Office Action Summary	Application No.	Applicant(s)	
	10/565,566	TAKAGI ET AL.	
	Examiner	Art Unit	
	Jeffrey O'Brien	3677

DETAILED ACTION

2. Claims 1-3 are rejected under 35 U.S.C. 102(e) as being anticipated by Minami et al (“Minami”, U.S. Patent No. 6,886,221).

Annotated Fig. 1

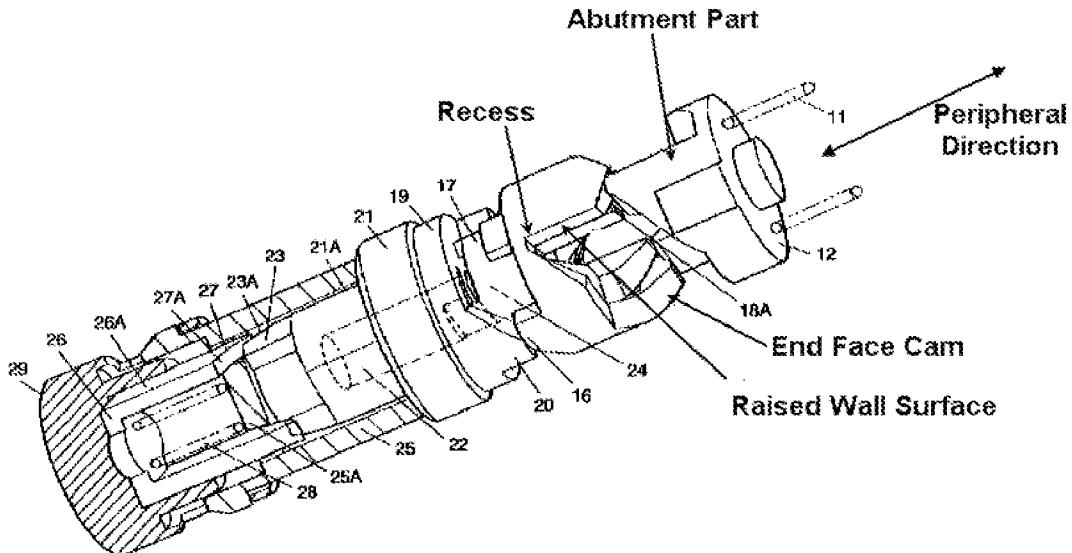
Minami discloses a hinge apparatus comprising a first hinge member (12) and a second hinge member (25) turnably connected to the first hinge member, a movable member (14) arranged on a turning axial line of the first and second hinge members in such a manner as to be turnable about the turning axial line and movable in the direction of the turning axial line (Figs. 1-7B). Biasing means (3) are adapted to bias the movable member (14) toward the first hinge member (12). The first hinge member and the movable member have confronting surfaces (Figs. 5A-7B). One of the confronting surfaces is provided a plurality of end face cam surfaces (upper surface of movable member 14 that faces towards 12, see figure below) extending in a peripheral direction about the turning axial line and equally spacedly arranged in the peripheral direction about the turning axial line (see figure below). A raised wall surface (vertical wall next to 15A) disposed between two of the end face cam surfaces that are adjacent in the

peripheral direction (see figure below), a distal end portion of said raised wall surface extending toward the other of said confronting surfaces in the direction of the turning axial line. The other of the confronting surfaces of the first hinge member and the movable member (14) is provided with a pair of abutment parts (13) that are urged against the pair of end face cam surfaces by the biasing force of the biasing means and co-acts with the pair of end face cam surfaces to convert the biasing force of the biasing means to a turn biasing force for turning the second hinge member (25) through the movable member (14). A recess (as seen in annotated Fig. 1) is formed a basal end portion of the raised wall surface and located at the intersection of the raised wall surface and the end face cam surface so as to extend into the raised wall portion in the peripheral direction about the turning axial line and arranged on an extension of the end face cam surface. The raise wall surface is located between the recess and the other of the confronting surfaces in the direction of the turning axial line (when the lowermost part of the end face cam surface is disposed in the lowermost part of end face cam surface of the one of the confronting faces and a surface of the end face cam of the other one of the confronting surfaces abuts the raised wall so that the face wall is between the recess and the other of the confronting surfaces in the direction of the turning axial line).

3. With respect to claims 2 and 3, Minami discloses that one side surface of the recess forms part of the end face cam surface (see figure above). The end face cam surface has a length of at least 180 degrees in the peripheral direction (see figure above).

4. Applicant's arguments filed 6/29/2010 have been fully considered but they are not persuasive.
5. Regarding Claim 1, Applicant argues that the recess does not extend in the peripheral direction. Applicant relies on the annotated Figure found in the arguments which has an arrow indicating a peripheral direction. Examiner, however, interprets the

peripheral direction of the movable member 14 to be that indicated in the above Annotated Fig. 1. It is pointed out that given the broadest reasonable definition, “peripheral” can be taken to mean “outer boundary”. The outer bounding edge of the movable member 14 can be taken as both the upper and lower edge of the movable member. As such, the recess indicated in the annotated Fig. 1 extends in the direction of the upper and lower edge of the movable member 14 and therefore extends into said raised wall surface in the peripheral direction.
